POLICY REPORT DEVELOPMENT AND BUILDING

SUBJECT: CD-1 By-law Text Amendments and Revised Rezoning Conditions: 2-88
West 1st Avenue, 2-26 East 1st Avenue, and 27-99 West 2nd Avenue

2-88 West 1st Avenue, 2-26 East 1st Avenue, and 27-99 West 2nd Avenue
URBAN DESIGN PANEL MINUTES

Figure 2 - Proposed Heights for Sub-area 2

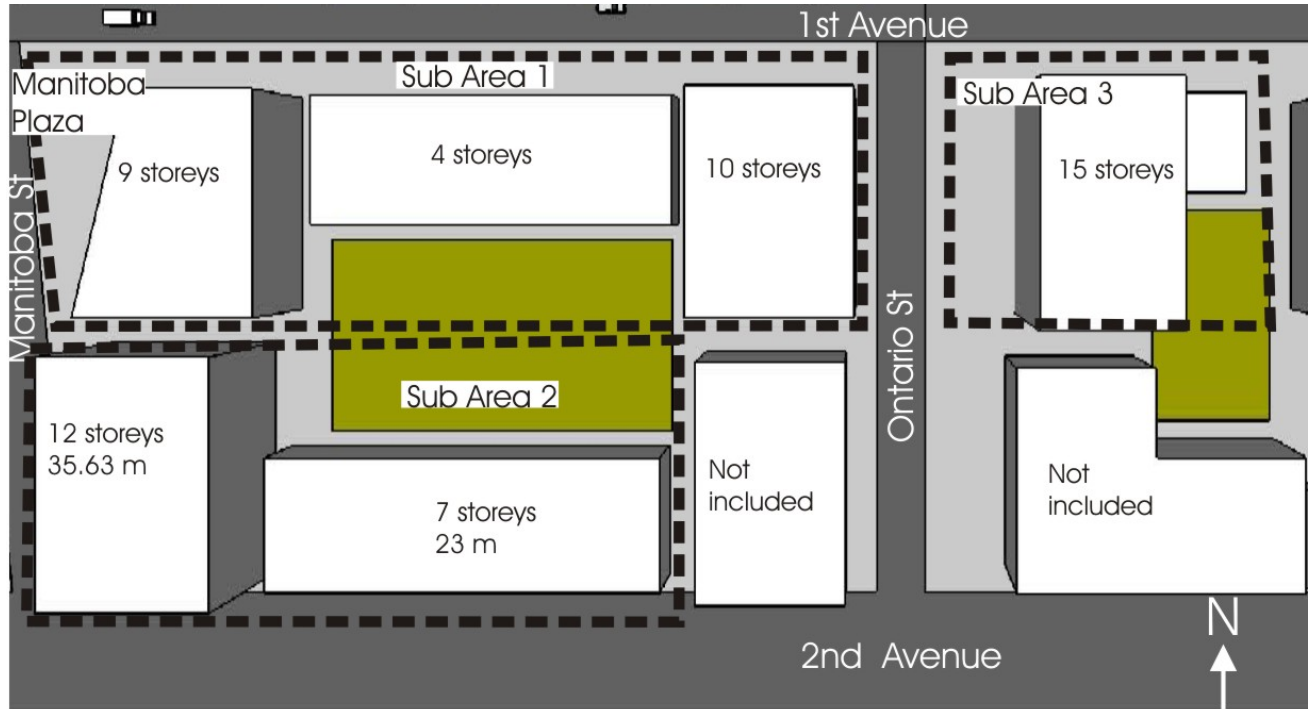
Staff have reviewed the proposed adjustment to the mid-rise tower and mid-block building. The proposed modest increase in height does not result in any increase in density, but rather redistributes the massing in such a way as to create a slimmer tower. The height increase does not result in any significant additional shadowing on public open space, such as the Manitoba Plaza area to the north (see: page 4 of Appendix C). Neither does it have significant impacts on private views immediately to the south, as this area is predominately industrial use. The height changes, in the view of staff, improve the overall urban design of the development.

The Urban Design Panel considered the Development Permit Application and the revised Form of Development on January 16th, 2008 and supported the changes to the building massing by a majority vote. (see: Urban Design Panel comments, Appendix C)

Staff support the proposed adjustments to the Form of Development and the proposed height increase.

2-88 West 1st Avenue, 2-26 East 1st Avenue, and 27-99 West 2nd Avenue
SHADOW DIAGRAM

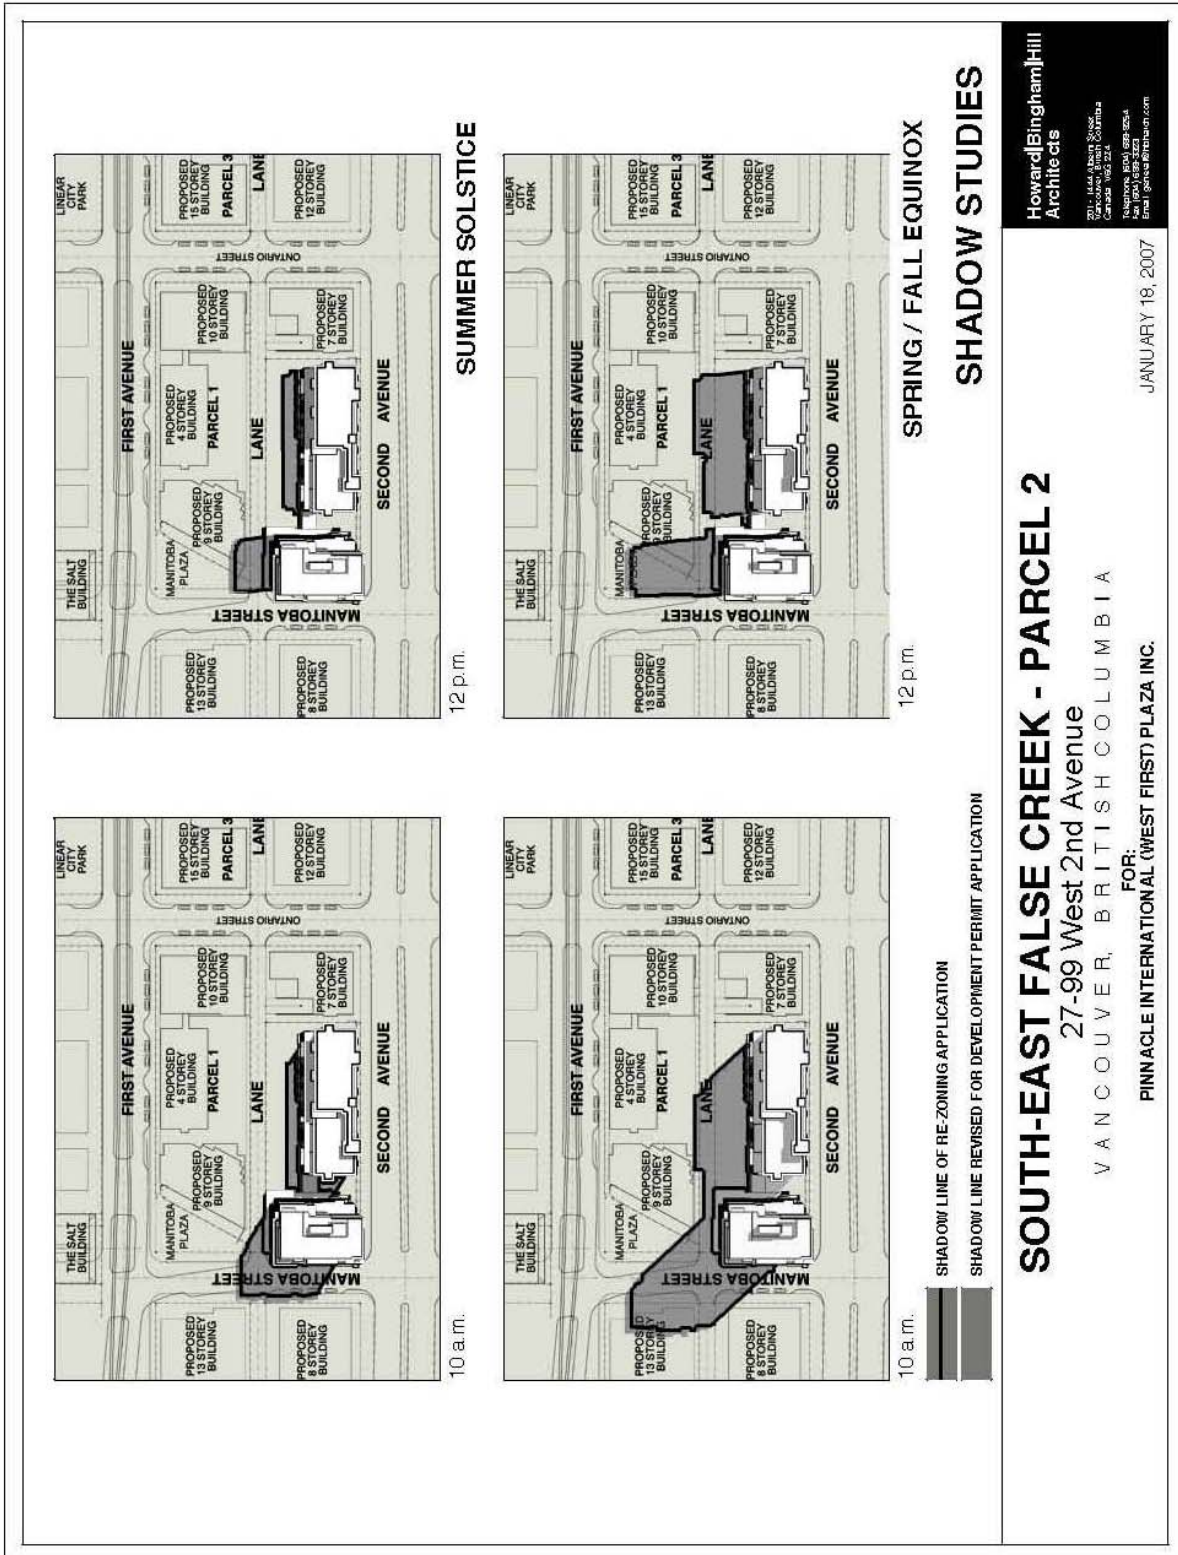
SHADOW LINE OF RE-ZONING APPLICATION
SHADOW LINE REVISED FOR DEVELOPMENT PERMIT APPLICATION
